NEW FLYER

SERVICE MANUAL BULLETIN

SMB-115B

1. CNG Fuel System

Fig. 1: Inline PRD Installation

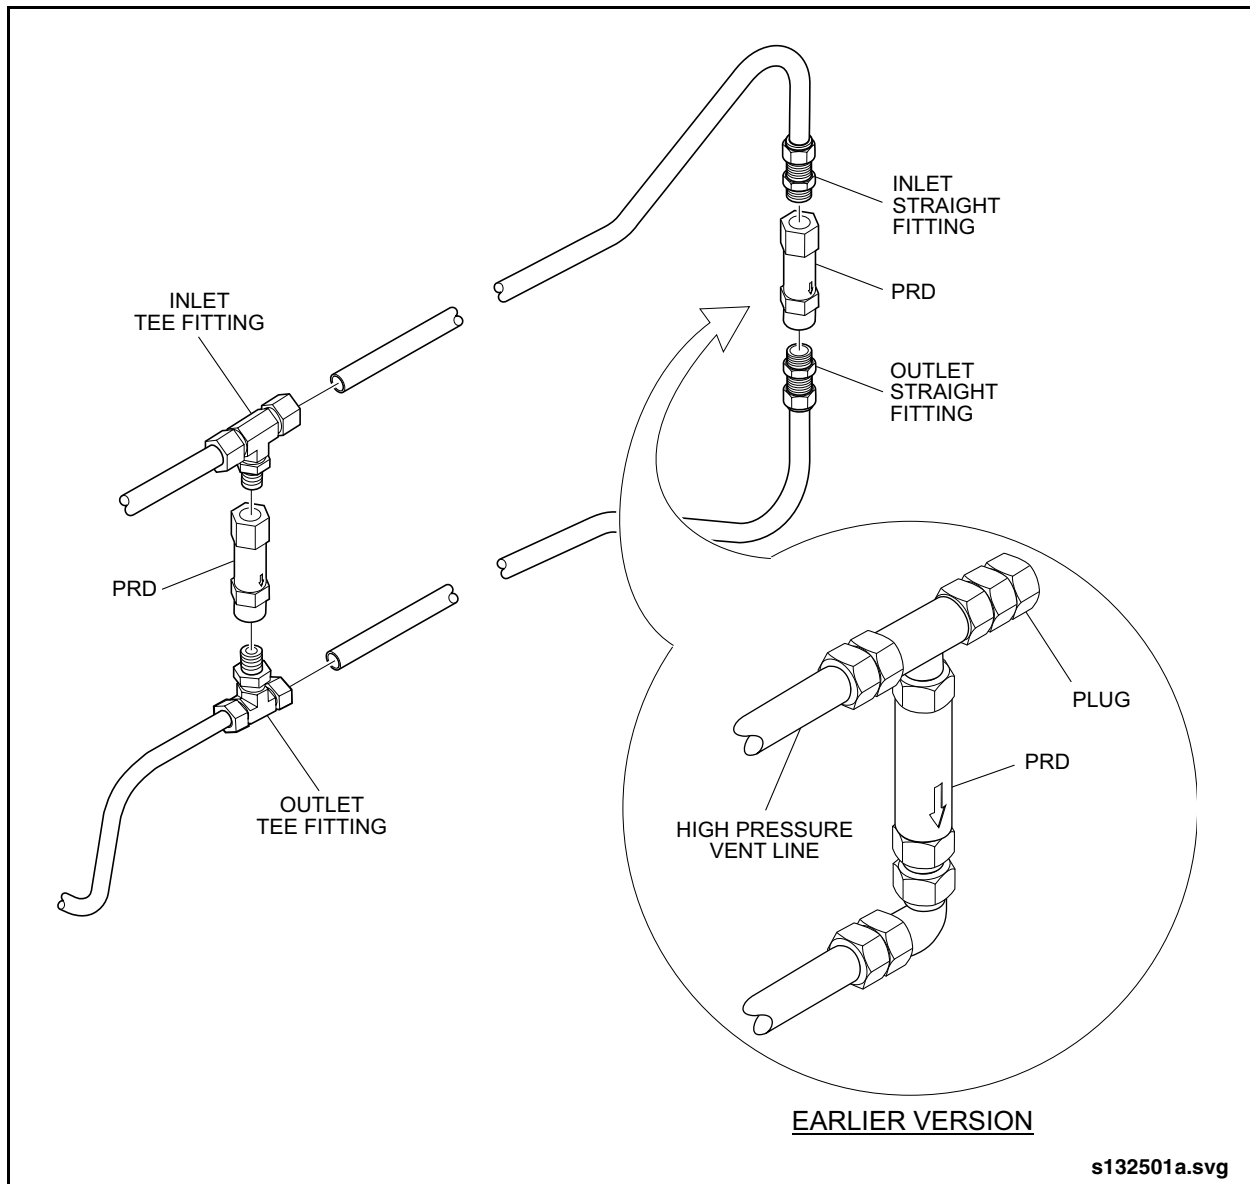
Ensure directional arrow stamped on body of PRD is pointing in direction of flow, toward vent line outlet.

1. Install the tee fitting into the inlet of the PRD as follows:
 - a. Fully retract the adjustment nut on the tee fitting.
 - b. Lightly lubricate new O-ring with silicone grease and install against the backup washer on the tee fitting.

- c. Thread the tee fitting into inlet of PRD until lightly seated.
 - d. Loosen tee fitting sufficiently to align parallel with vent lines when installed.

- e. Tighten adjustment nut until lightly seated. Do not final tighten adjustment nut at this time.
2. Install the elbow fitting into the outlet of the PRD as follows:

- a. Fully retract the adjustment nut on the elbow fitting.
 - b. Lightly lubricate new O-ring with silicone grease and install against the backup washer on the elbow fitting.

- c. Thread the elbow fitting into inlet of PRD until lightly seated.
 - d. Loosen elbow fitting sufficiently to align with vent line when installed.
 - e. Tighten adjustment nut until lightly seated. Do not final tighten adjustment nut at this time.

3. Align the fittings on the PRD, with the vent lines, ensuring the directional arrow on the PRD body is pointing in the direction of flow, toward the vent line outlet.

ALWAYS tighten PRD fittings to the torque value specified for the inlet and outlet location on the PRD. Torque values for the inlet and outlet fittings are different and must be adhered to in order to prevent damage to the PRD body.

5. Final tighten the adjustment nut on the inlet fitting with one wrench while holding the body of the PRD with another wrench. Torque adjustment nut to specification. [Refer to 1.3.3. "PRD Torque Values" on page 8](#) in this bulletin for torque specification.
6. Final tighten the adjustment nut on the outlet fitting with one wrench while holding the body of the PRD with another wrench. Torque adjustment nut to specification. [Refer to 1.3.3. "PRD Torque Values" on page 8](#) in this bulletin for torque specification.

Fig. 2: Tank-End PRD Installation

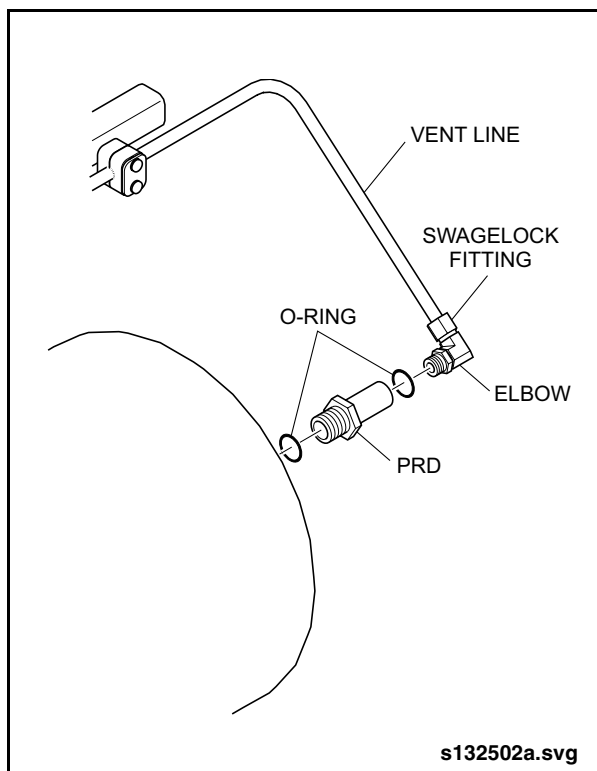
DO NOT overtighten PRD. Threaded boss in tank is made of aluminum and can be damaged if PRD is overtightened. ALWAYS torque to specification.

DO NOT apply excessive lubricant to the O-ring on the PRD. Excessive lubricant can prevent the O-ring from sealing properly. Use only a minimal amount of lubricant on the O-ring.

1. Lightly lubricate the new O-ring with silicone grease and ensure it is properly installed in the O-ring groove of the PRD.
2. Install the new PRD into the threaded boss of the tank and torque to 90 to 110 ft-lb. (122 to 149 Nm).
3. Install the elbow fitting into the outlet of the PRD as follows:
 - a. Fully retract the adjustment nut on the elbow fitting.
 - b. Lightly lubricate new O-ring with silicone grease and install against the backup washer on the elbow fitting.
 - c. Thread the elbow fitting into PRD until lightly seated.
 - d. Loosen elbow fitting sufficiently to align with vent line when installed.
